BALTIMORE GAS AND ELECTRIC COMPANY

Subject: Calvert Cliffs Nuclear Power Plant
Unit No. 2, Docket No. 50-318
Supplementary Information on Reload
Application Request

Reference: (a) BG&E letter dated 7/26/78 from Lundvall to
Reid, Request for Amendment.
(b) BG&E letter dated 10/6/78 from Lundvall to
Reid, Supplement to Reload Application

Figure
3.2-2

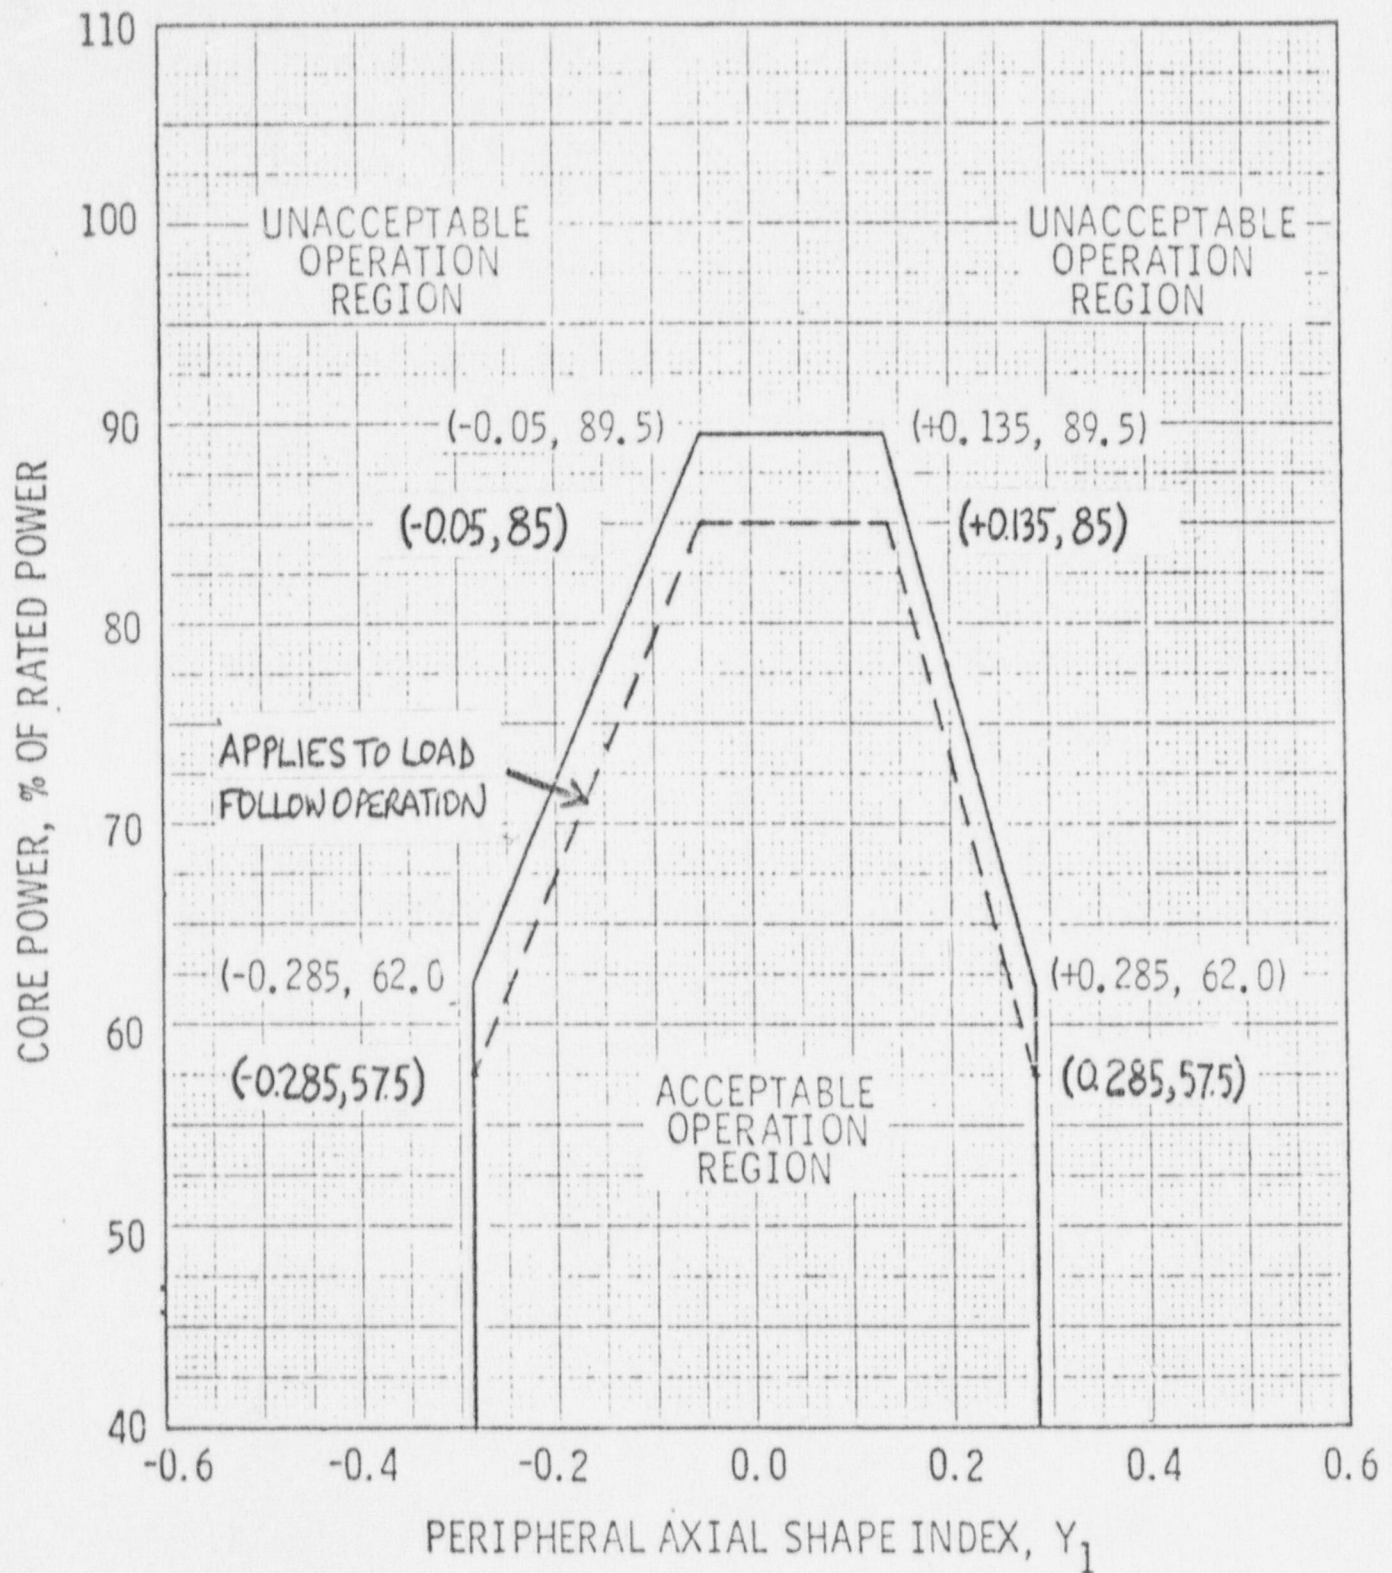
T/S page 3/4 2-4 (page 70 of Reference (a)) - change per attached
Figure to provide for load follow operation;

LINEAR HEAT RATE
AXIAL FLUX OFFSET CONTROL LIMITS
